A RESOLUTION OF THE TOWNSHIP OF NORTH BRUNSWICK AUTHORIZING AN AMENDMENT TO THE CONTRACT WITH PATRIOT ROOFING, INC. FOR THE MUNICIPAL COMPLEX ROOF AND GUTTER REPLACEMENT PROJECT CHANGE ORDER NO. 2

CHANGE ORDER

PROJECT: Roof Replacement at the Municipal Building

2083 Jacksonville-Jobstown Road, Jobstown, New Jersey 08041 CHANGE ORDER NO: 2

North Brunswick Municipal building. Extra gable framing

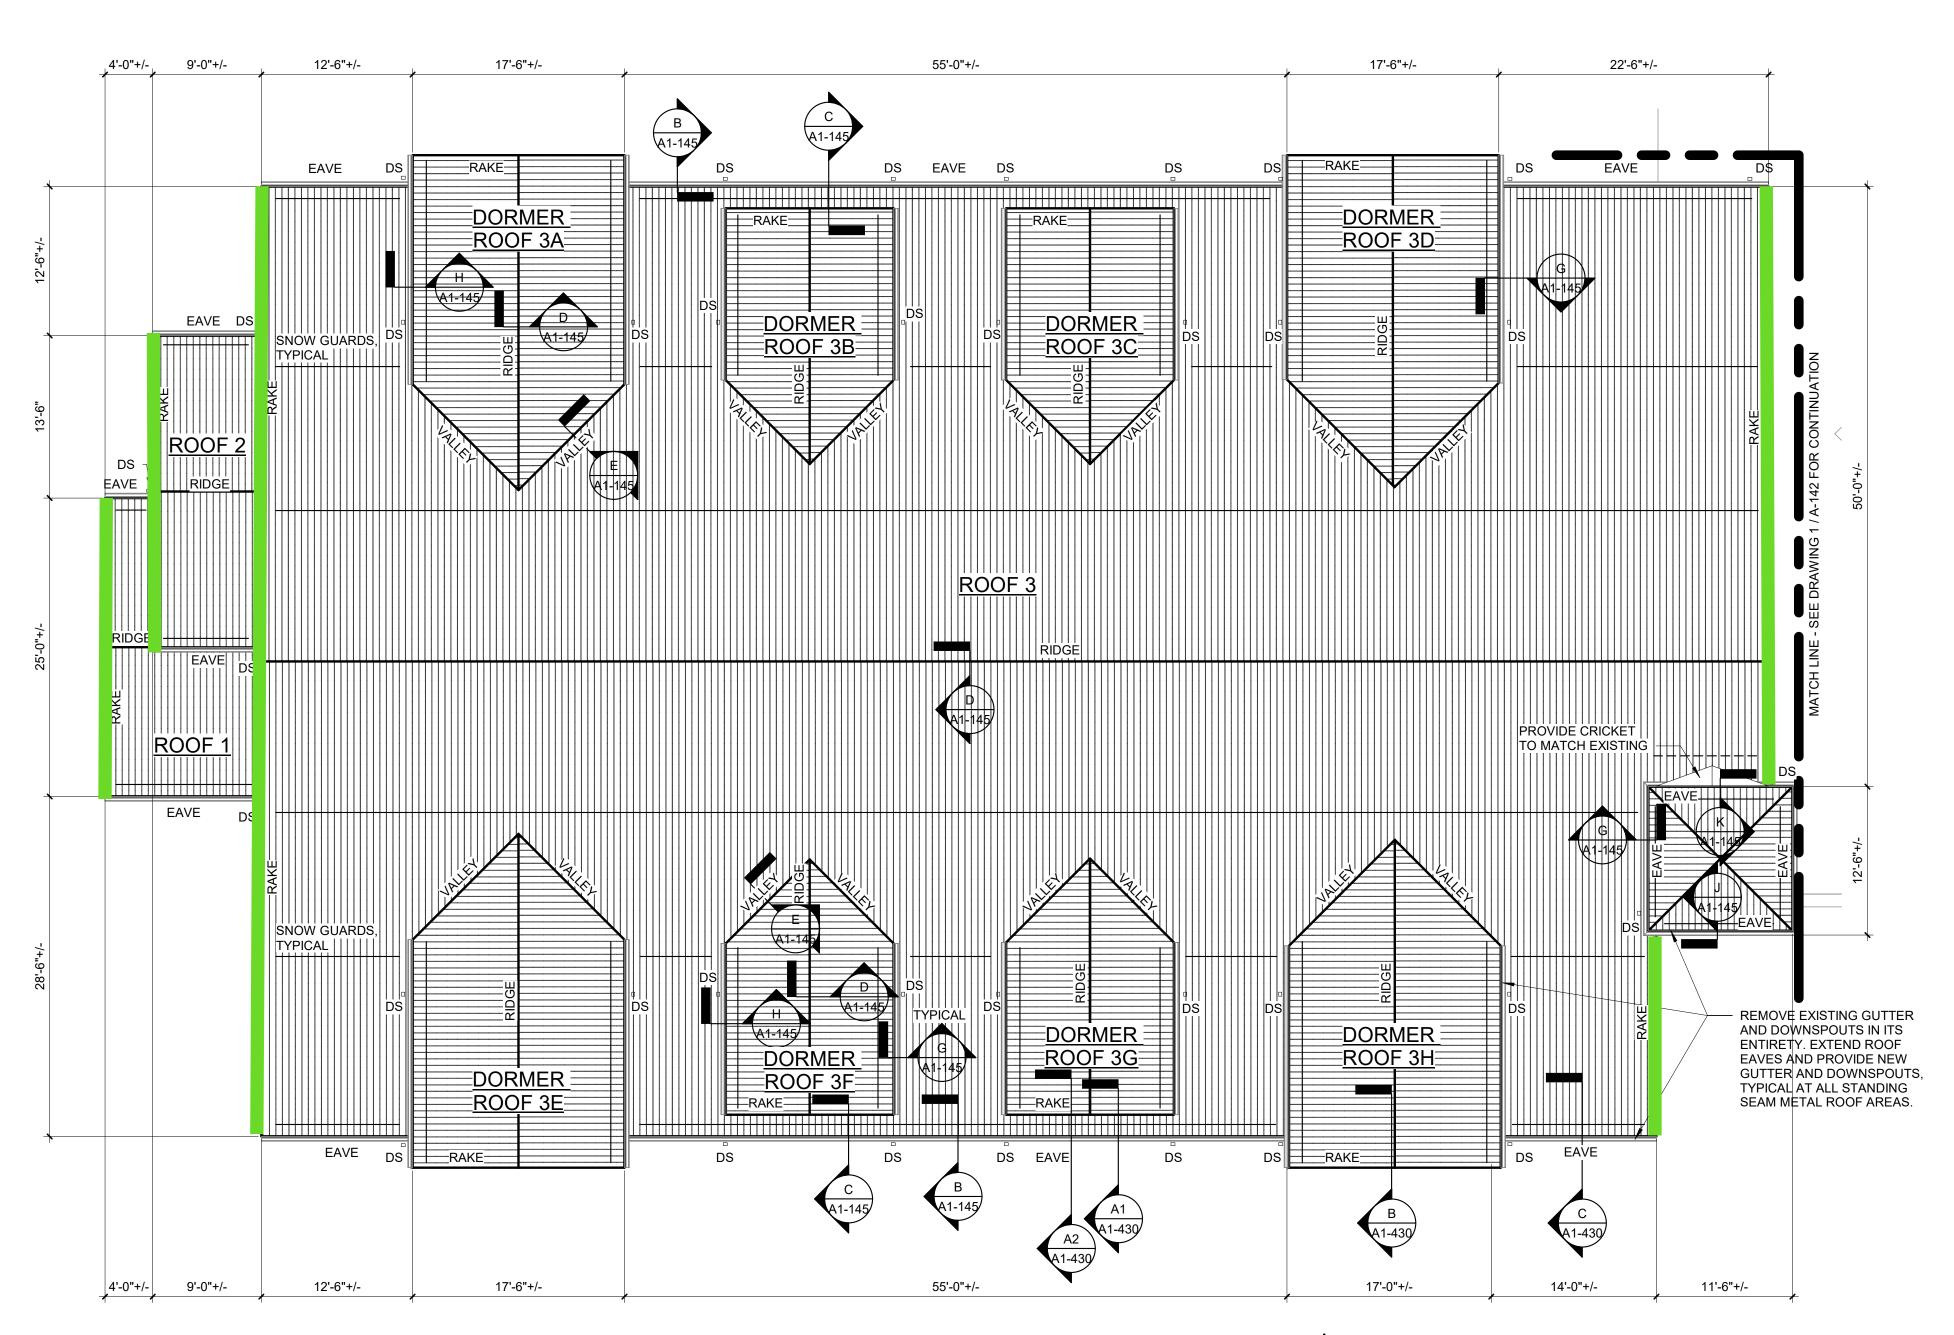
SCOPE OF WORK: Patriot Roofing to extend framing in 8 different areas total approximately 160 lineal feet.

- *Extend 2x6x 16-gauge studs, track and clips
- *Additional R-19 insulation, gypsum board and AVB
- *New soffit and trims
- *Add additional metal decking, insulation, ice and water shield.
- *Add 2x6 and plywood for edge condition.
- *Add addition 2x10 for gable fascia.
- *Add additional extended fascia.
- *Add one metal roof panel at each location.

Total Lump Sum \$\$80,000.00
